12 February 2014

**78-90 OLD CANTERNBURY ROAD, LEWISHAM  
SECTION 75W – AMENDMENT TO CONDITON 11 OF CONCEPT APPROVAL  
MP08-0195 (MOD6)**

DATE: 23 JAN 2014  
DRAWING: DA-1220-06 A  
SCALE: 1:200 @ A1

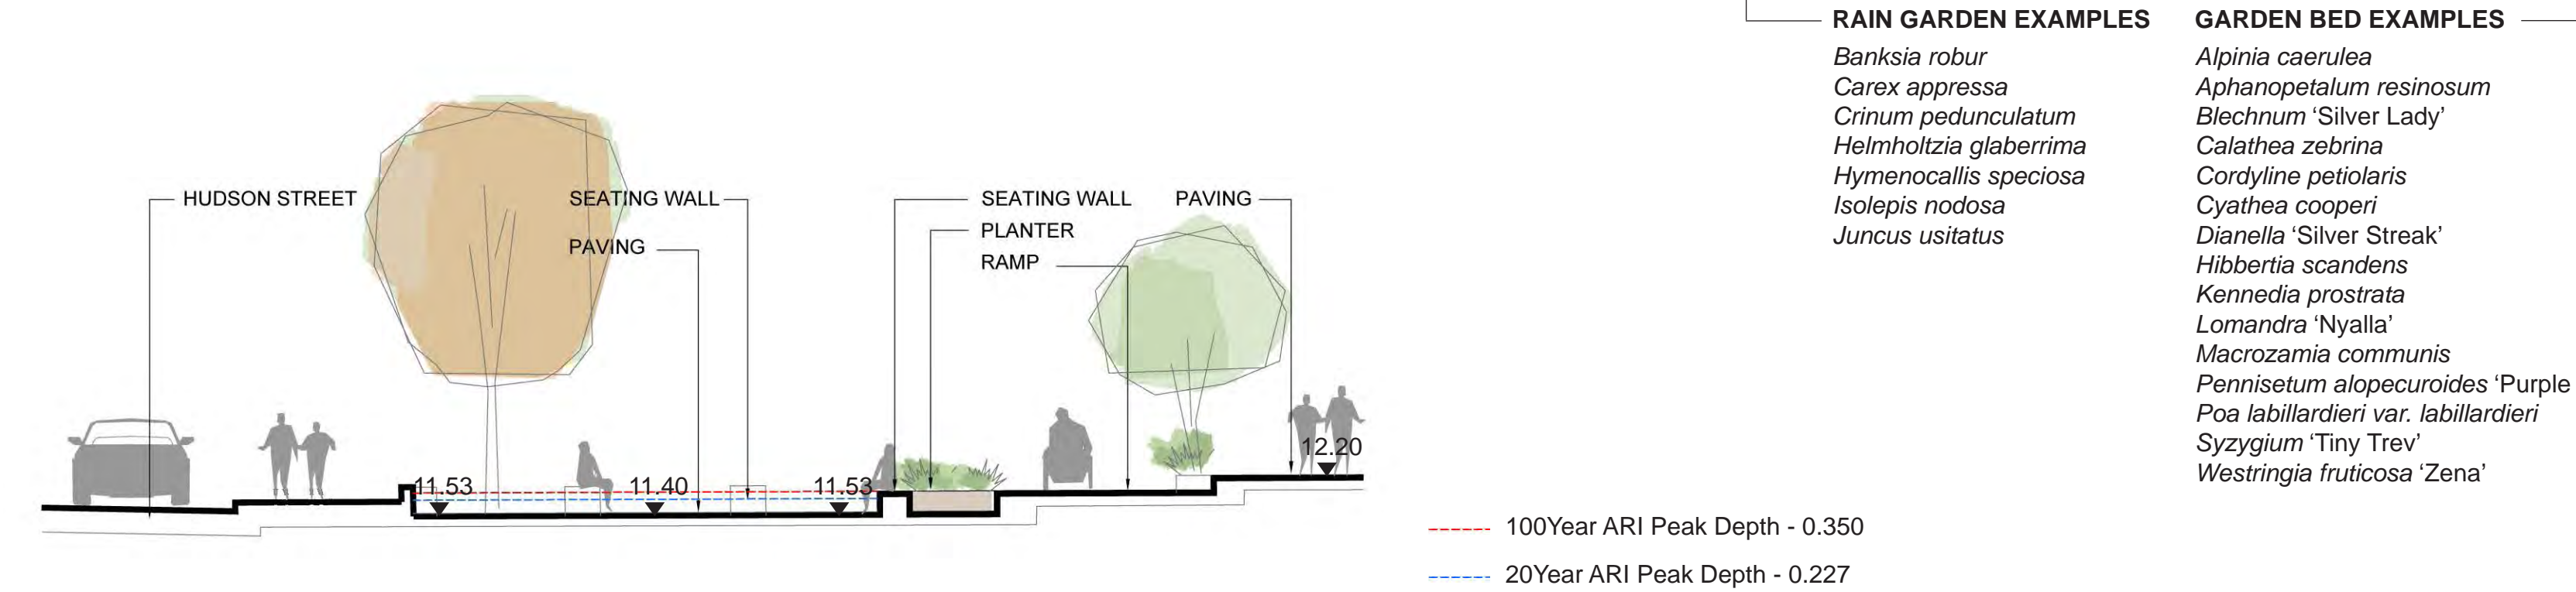
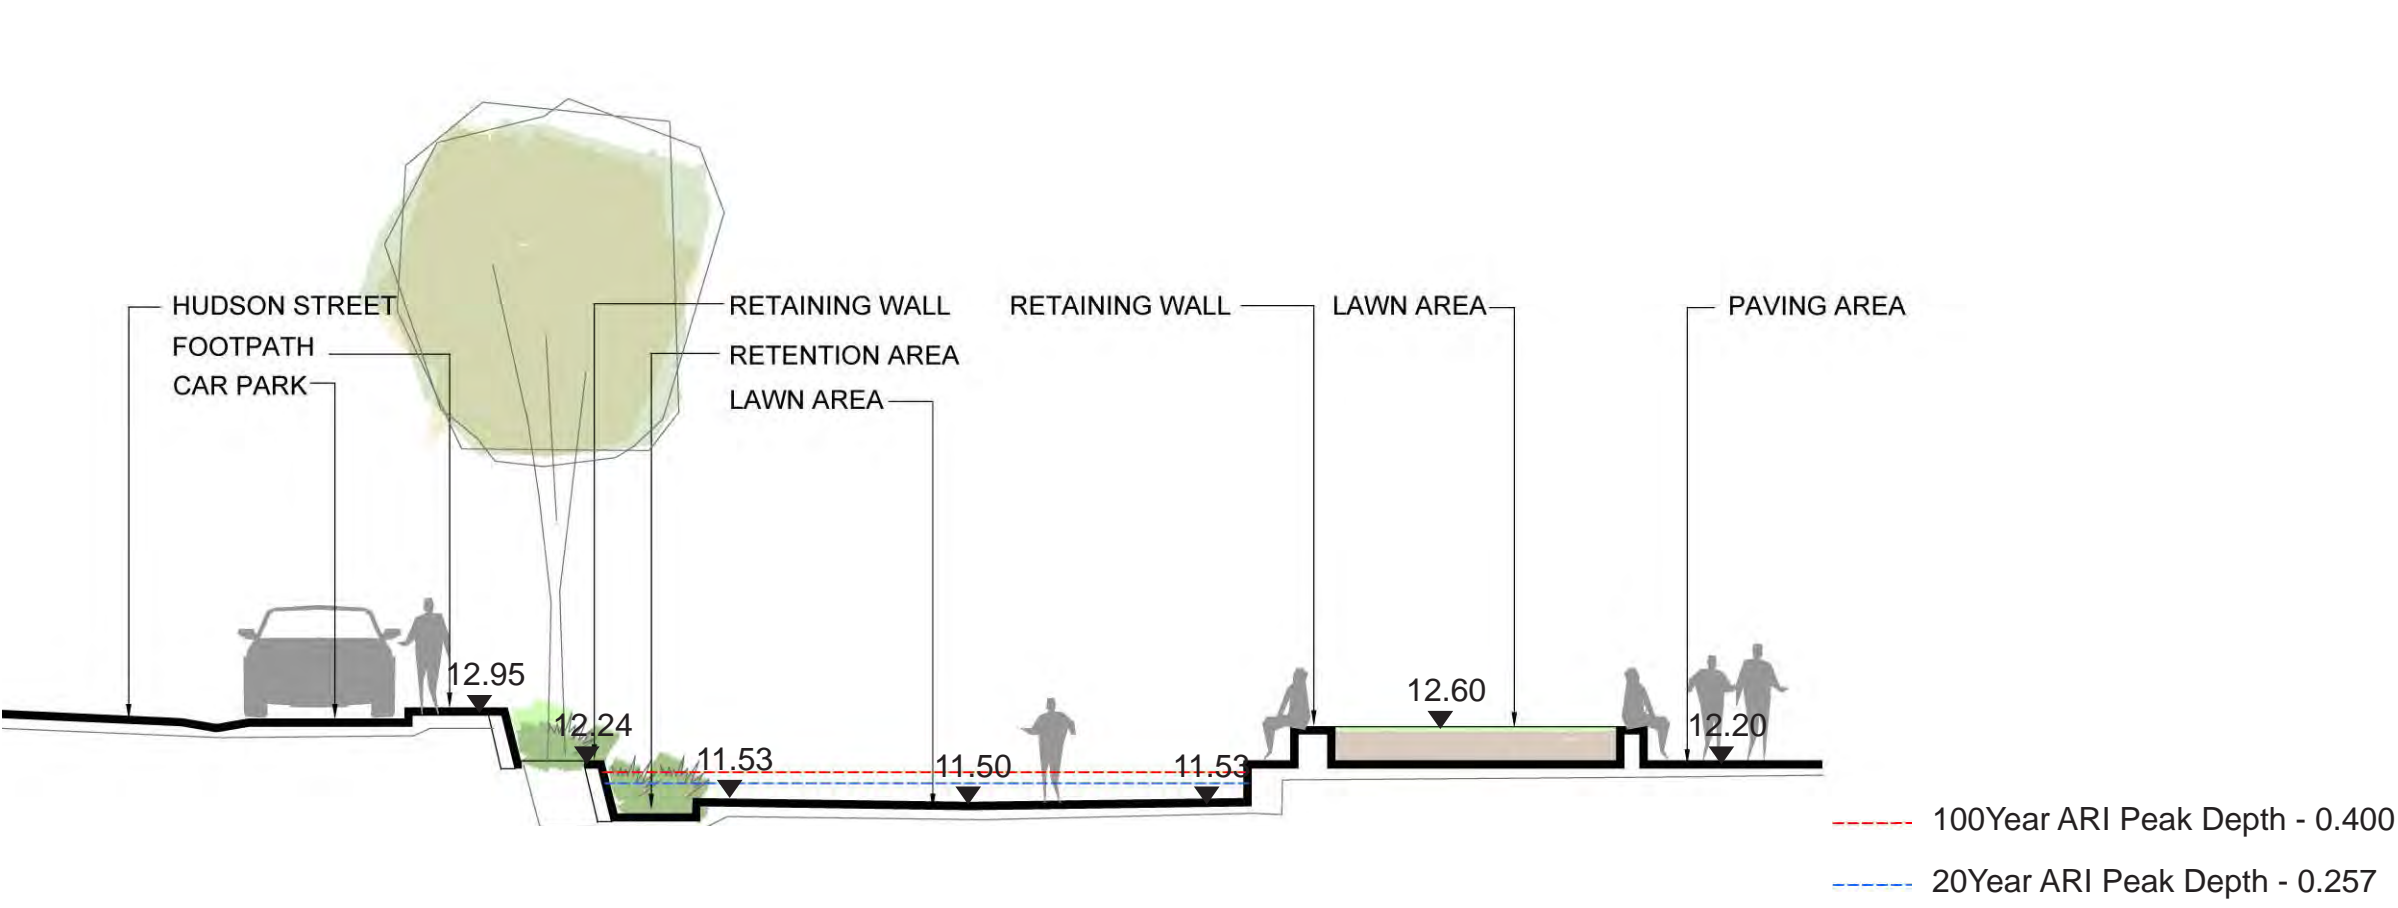
- *the amenity of the park will be diminished by introducing a drainage area and formal pathways through the open space.*
- *"Landscape plans integrating the drainage overland flow structure has not been provided to Council as part of the S75W application and in the absence of these details, the urban design implications of a combined open space/drainage reserve design are unknown."*

- *"Council is concerned that the design requirements of the drainage reserves may impede the ability of the open space to provide good amenity to all users. The drainage design drawings show that the overland flow path design requires a channel to be created in the middle of the open space that is approximately 700mm below the levels of the surrounding pathways/landscaping."*

We have prepared an integrated plan that consolidates the drainage requirements and open space uses. This plan is attached to **Annexure 2**. Importantly, the cross section shows the integration of seating, passive areas and paths to accommodate mixed uses within the open space that is typical of any open space area in Sydney. The maximum overland flow depth in will be approximately 400mm which is less than the 700mm estimated by Council. The amenity of the park is in no way compromised from this design.

- A slender gradient over the entire length of the open space area will be negligible in terms of open space useability. Relevant cross sections of the drainage swale are shown in **Annexure 2** and show depths of only 40cm of water remaining in a 1 in 5 year event for only 80 minutes.

Project	LEWISHAM ESTATE
Title	SITWORKS AND STORMWATER DRAINAGE PLAN - SHEET 1

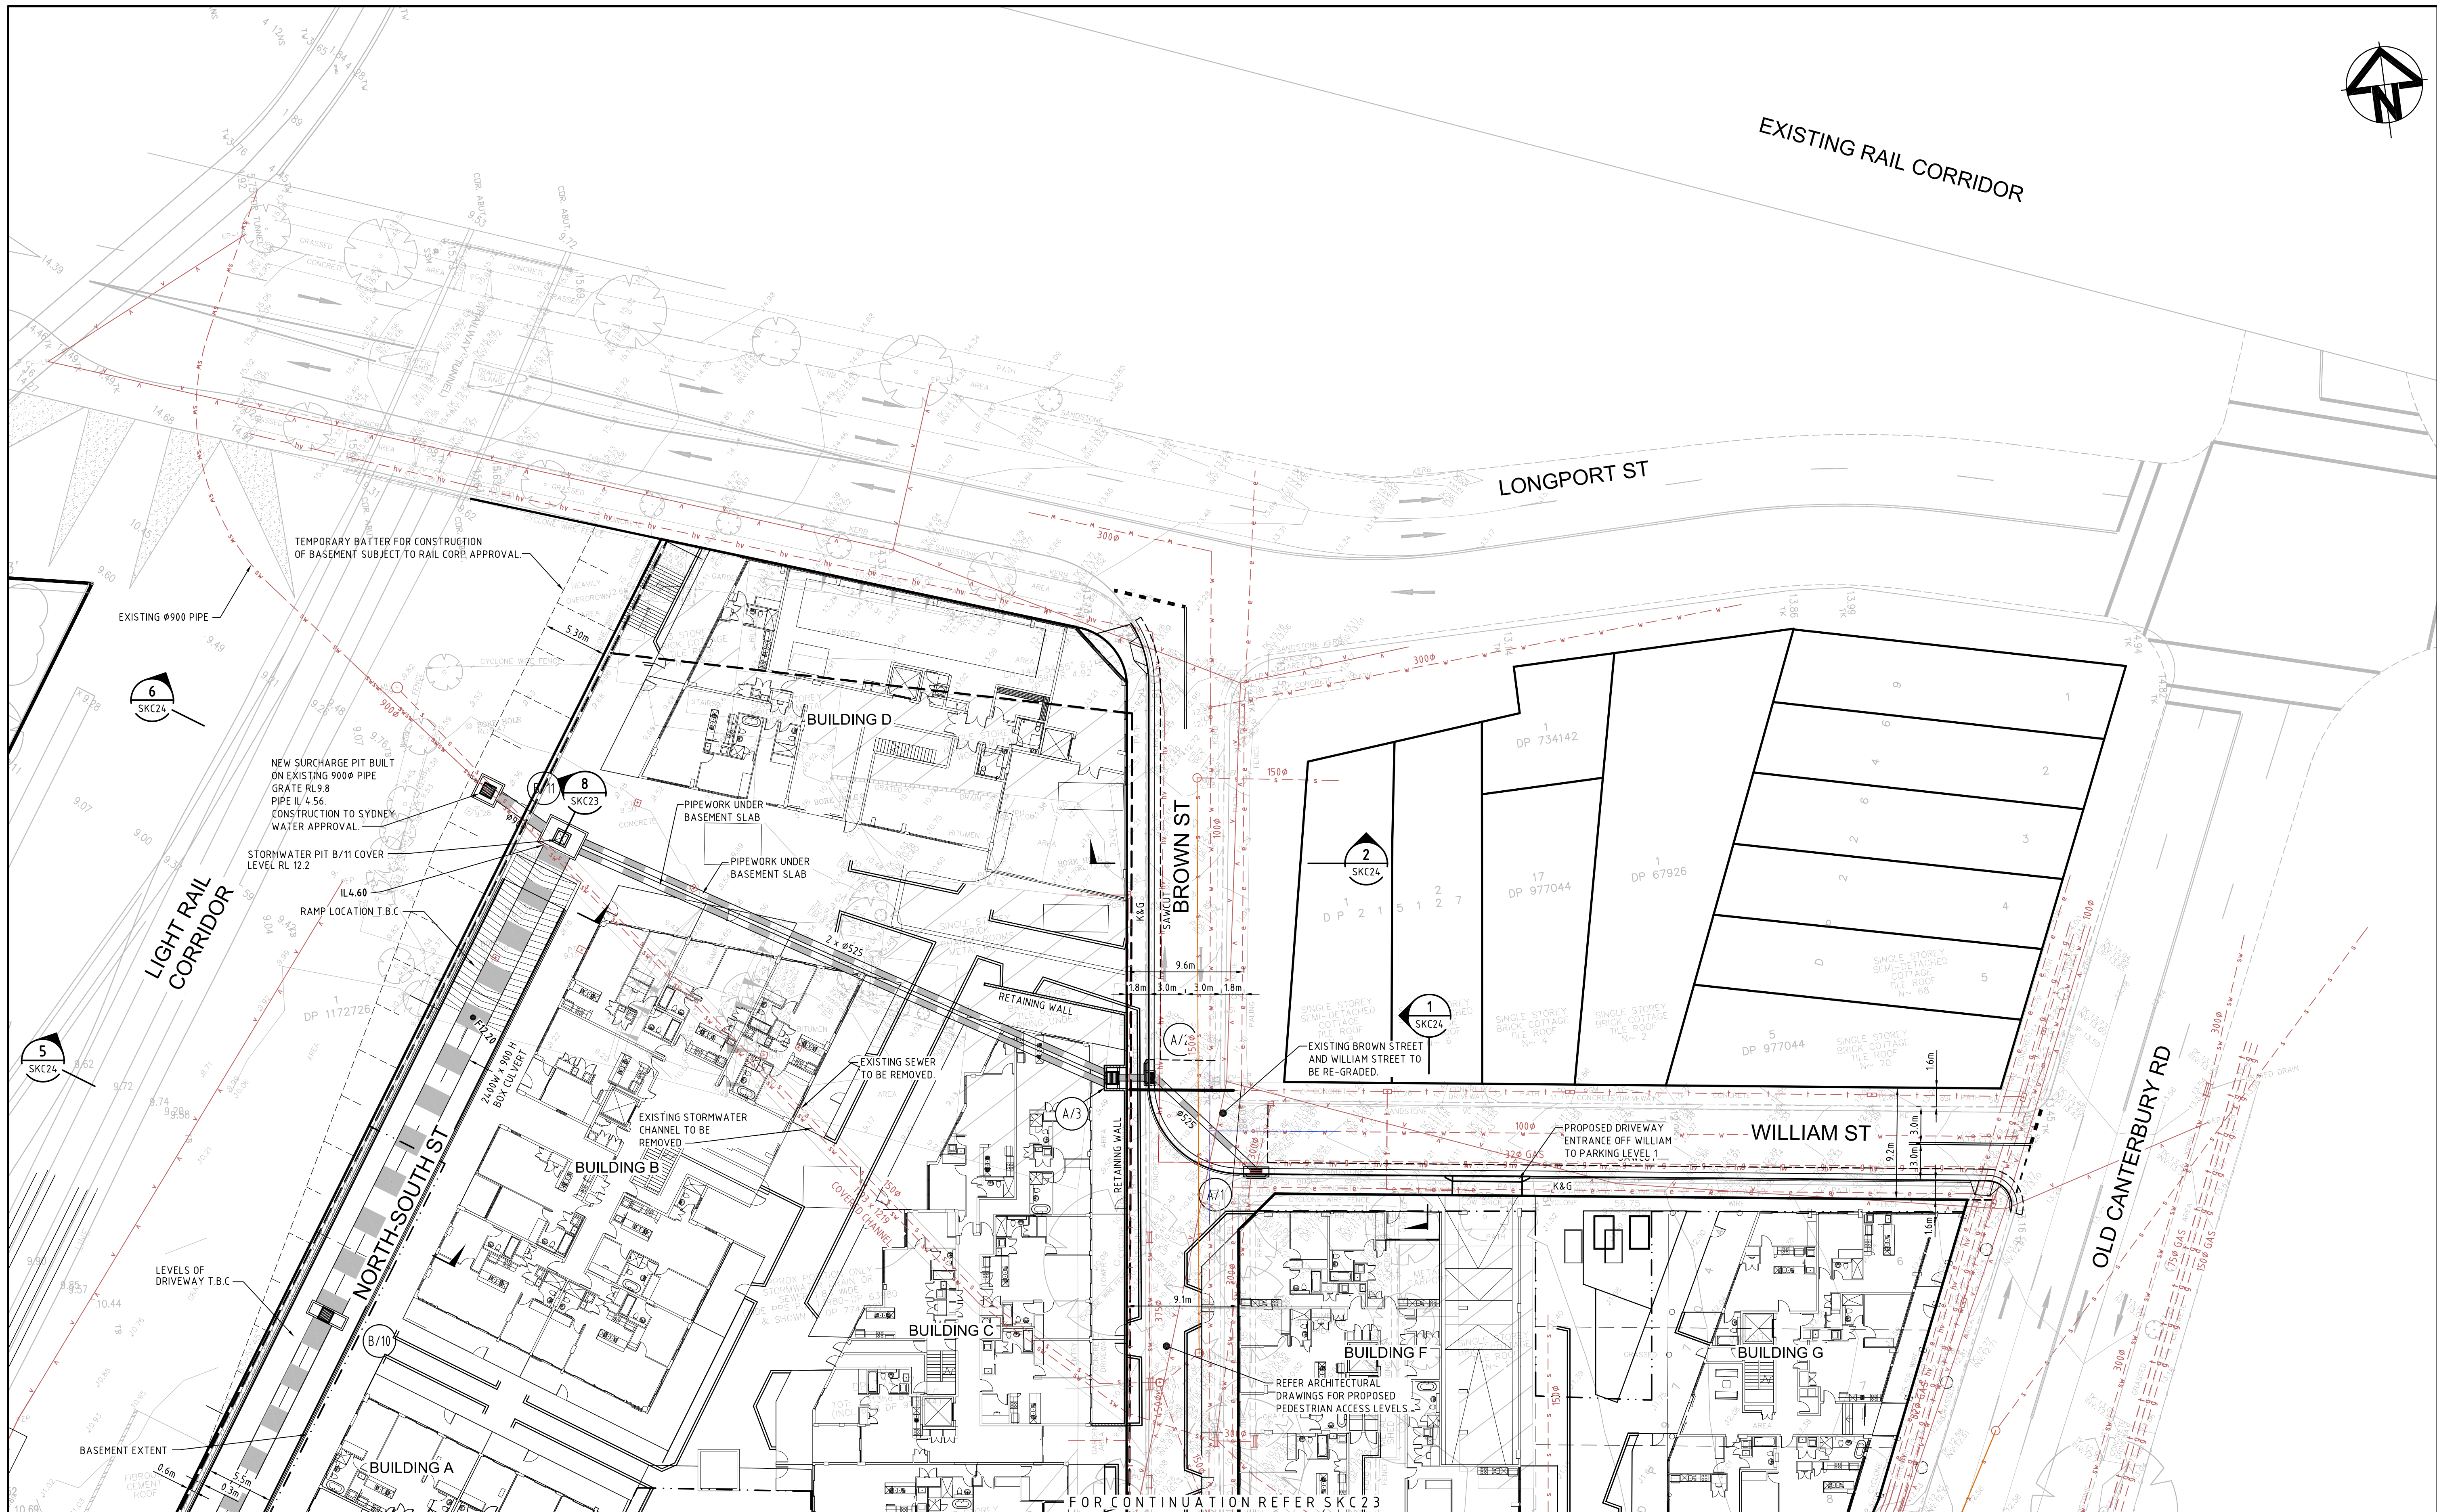
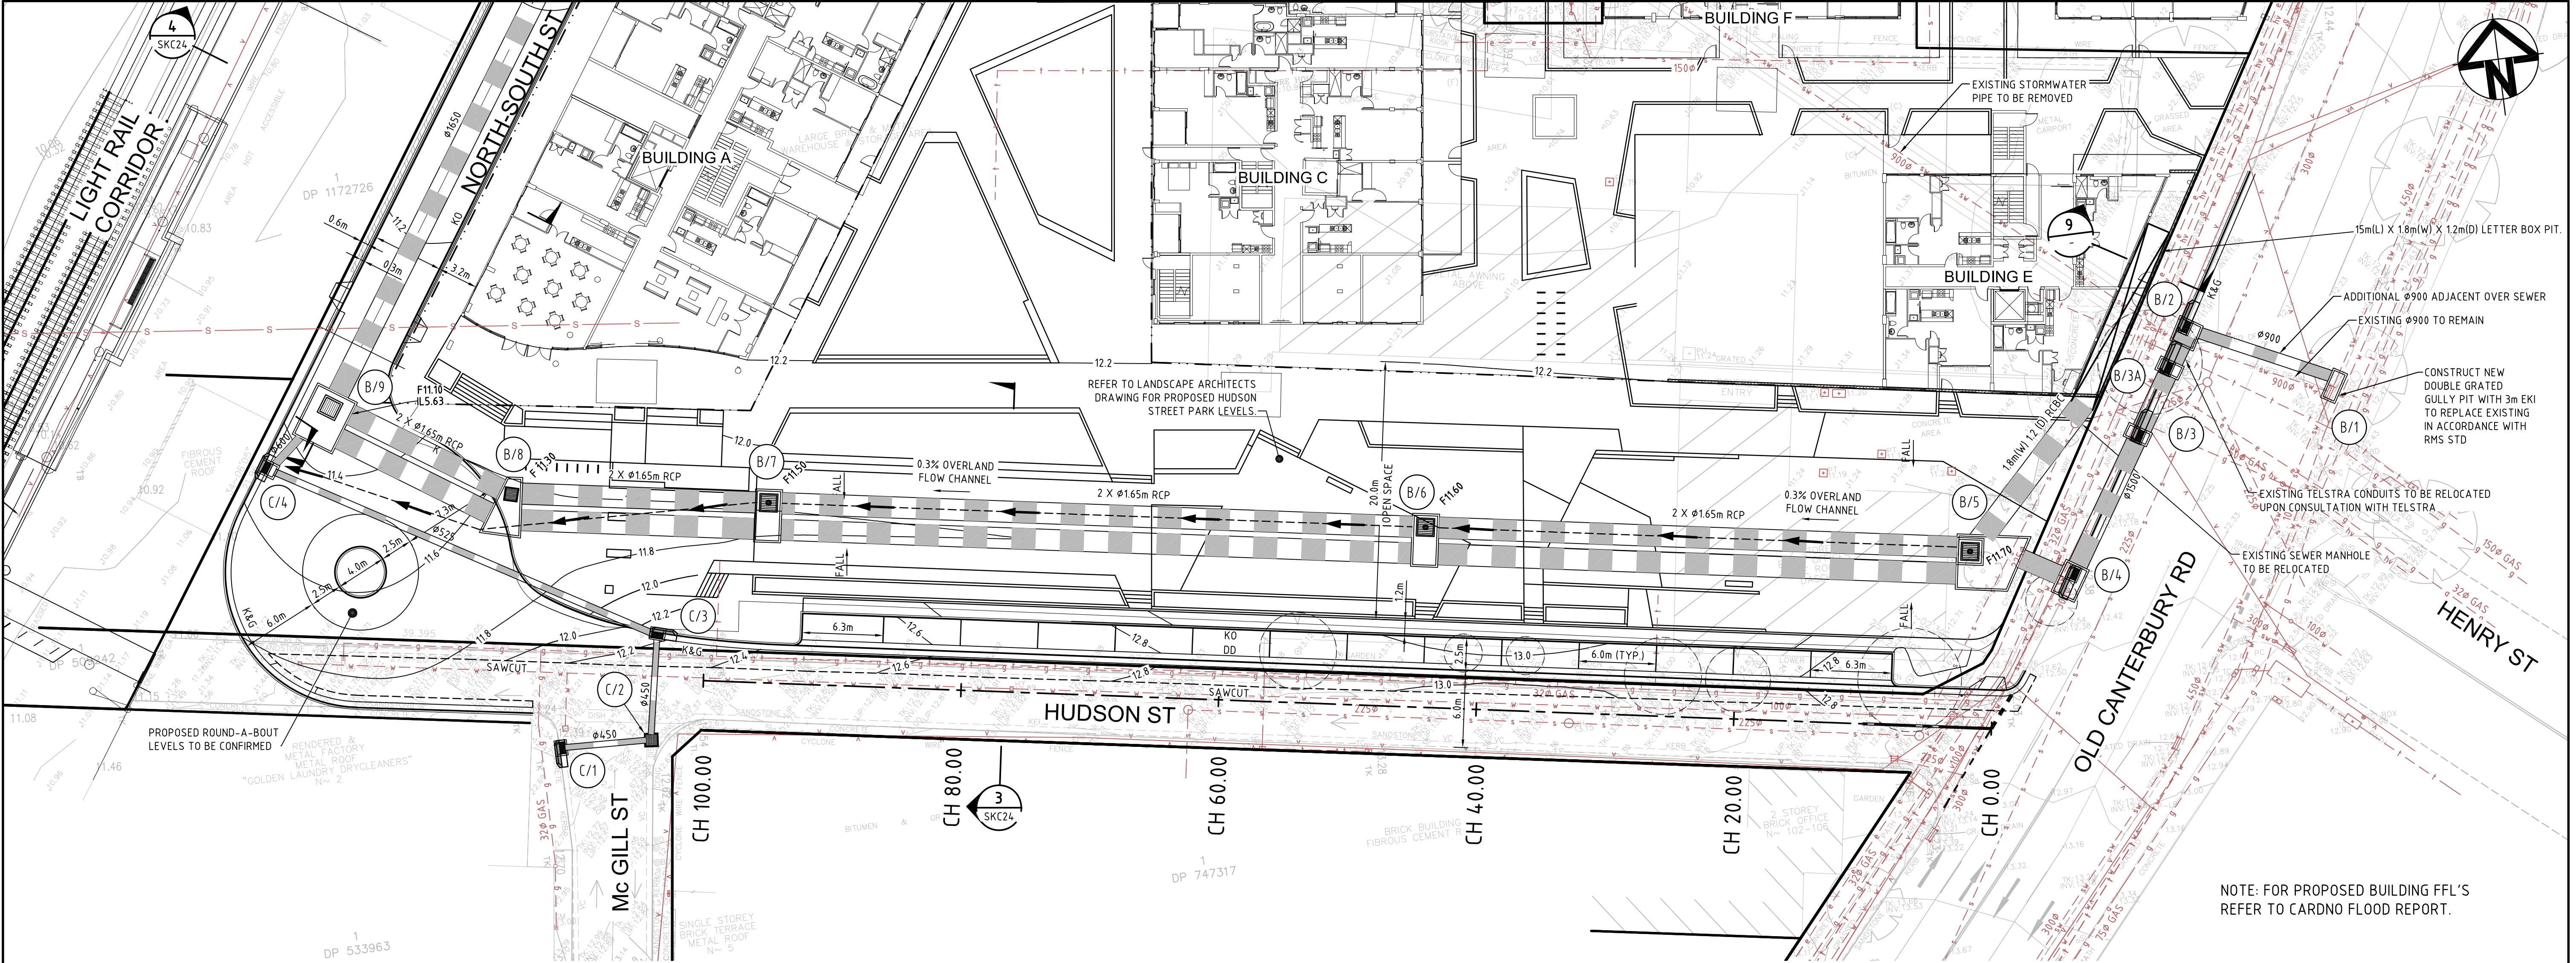
The proposed Lewisham Estate Drainage Works (report dated 18/10/13 and plans SK22, SK23 and SK25) are acceptable to Council in concept.

With any proposed future DA please ensure that a Flood Report is submitted including the following items;

- For background the discussion paper and addendum dated 14 August 2013 should be discussed and included in an appendix;
- For Clarity please ensure that Table 1 (from the discussion report dated 14 August 2013) or similar is reproduced with the final scheme included in the table;
- Check to see if there is a change in flood risk to surrounding properties
- Assess the overland flow paths for safety i.e. VxD relationship; and
- Tabulated HGL calculation which detail the pit loss coefficients used at each pit and the down tail water level used.
